Modifications to RRC messages and information elements required to support rapid DCH initialization procedures

Figure 2 UE-Originated DCH Activation with the minimum Iub round trips.

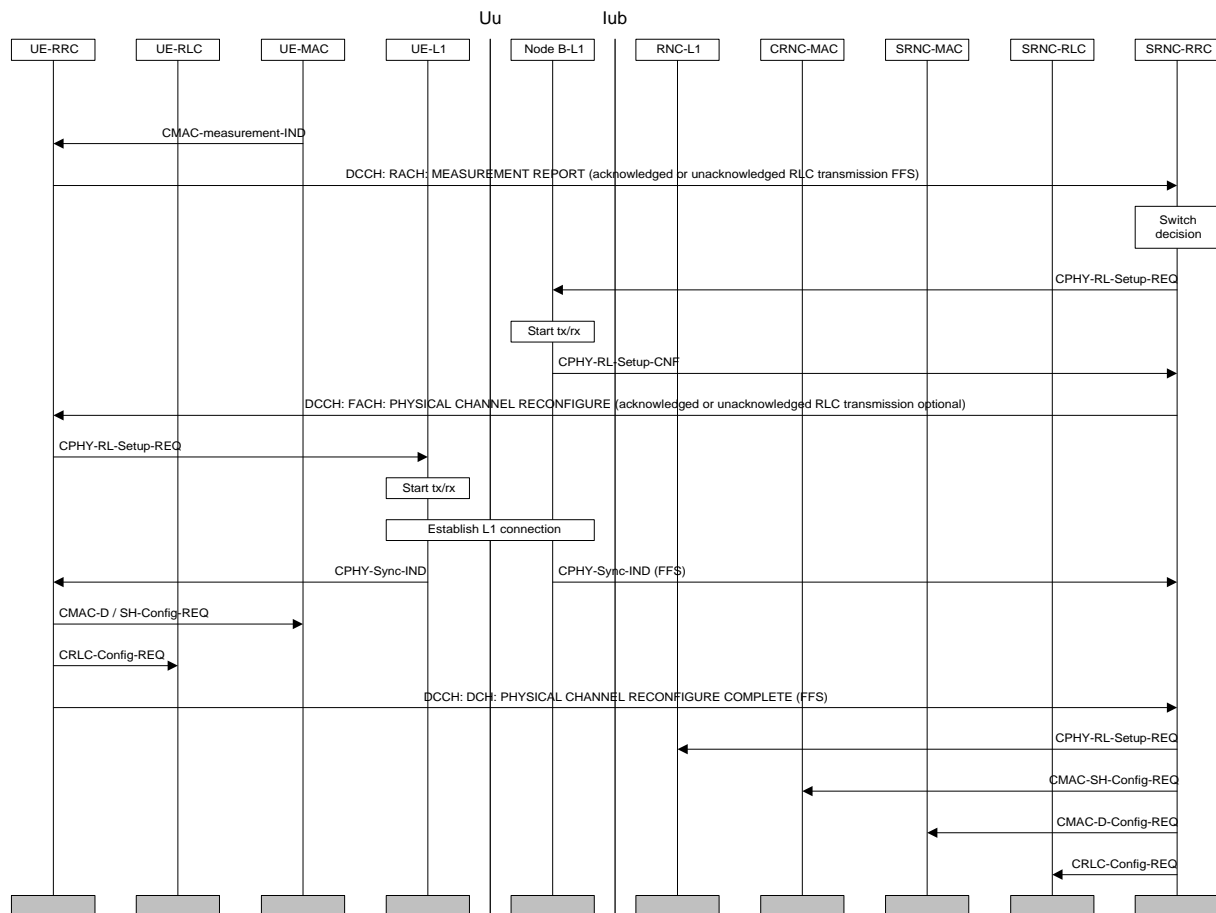
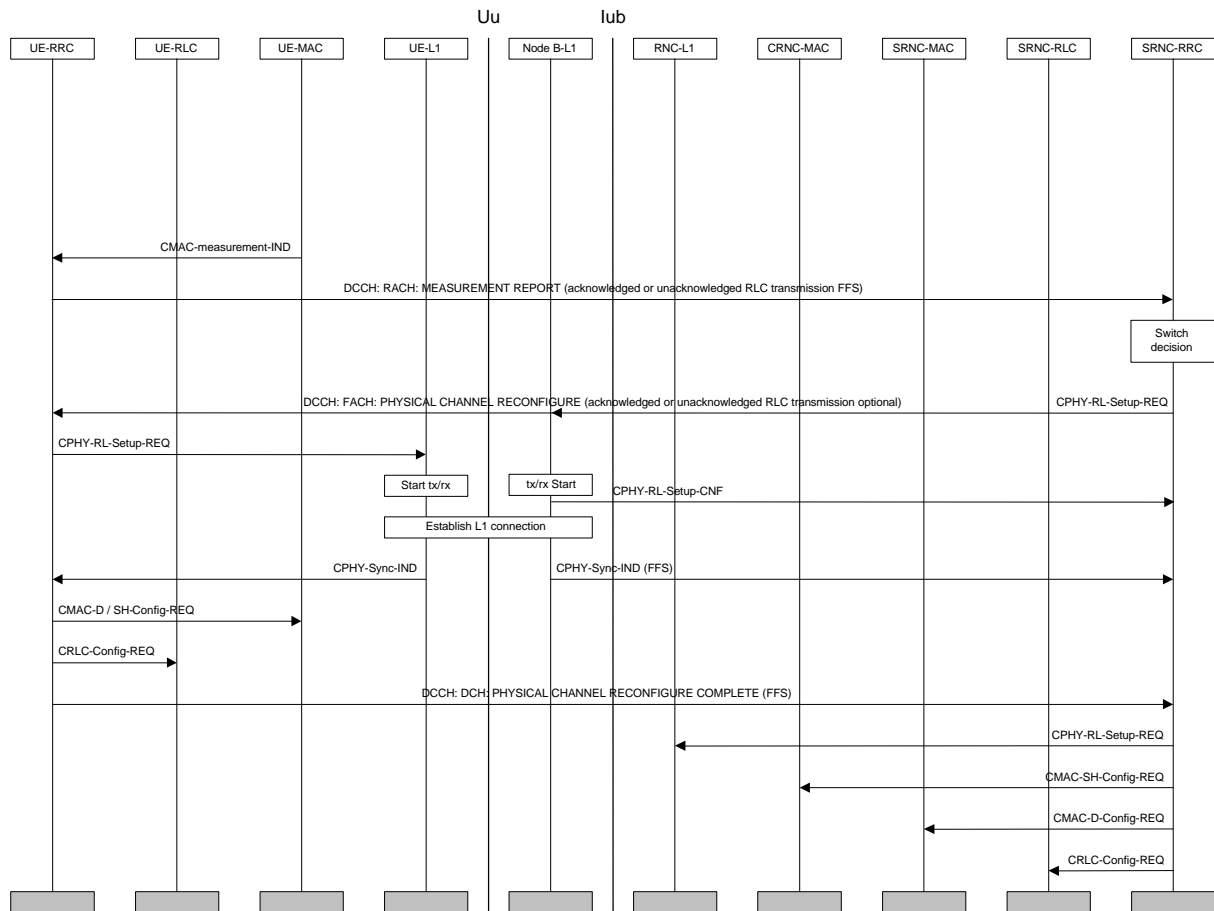
In order for the WG1 procedure to be effective inefficiencies in the Iub signalling must be eliminated. Three changes must be made:

- #1 The number of round trips across the Iub must be reduced, unnecessary messaging across the Iub will contribute to the data buffering delays.
- #2 The Node B must be able to reuse the channel estimate information from the previous RACH. The multipath profile changes slowly and the DCH acquisition time at the Node B may be minimised by re-using previous searcher information.
- #3 The RRC must be aware of the UE's signaling response time. (i.e. How long does it take for a UE to demodulate the FACH and re-configure it's physical layer?) WG1 has defined a set of parameters that specify a UE's capability.

With respect to change #1, Figure 2 below shows a modified version of Figure 1 that shows how the PHYSICAL CHANNEL RECONFIGURE message and physical layer primitives may be piggybacked to reduce the number of Iub round trips. With respect to change #2, the detailed description of the physical layer primitives must be extended so that RRC can reference previous RACH messages as part of CPHY-RL-Setup-REQ allowing the Node B to reuse channel information. The exact mechanism is FFS. Finally the next section identifies modifications to 25.331 to identify and configure aspects of the UE capability.
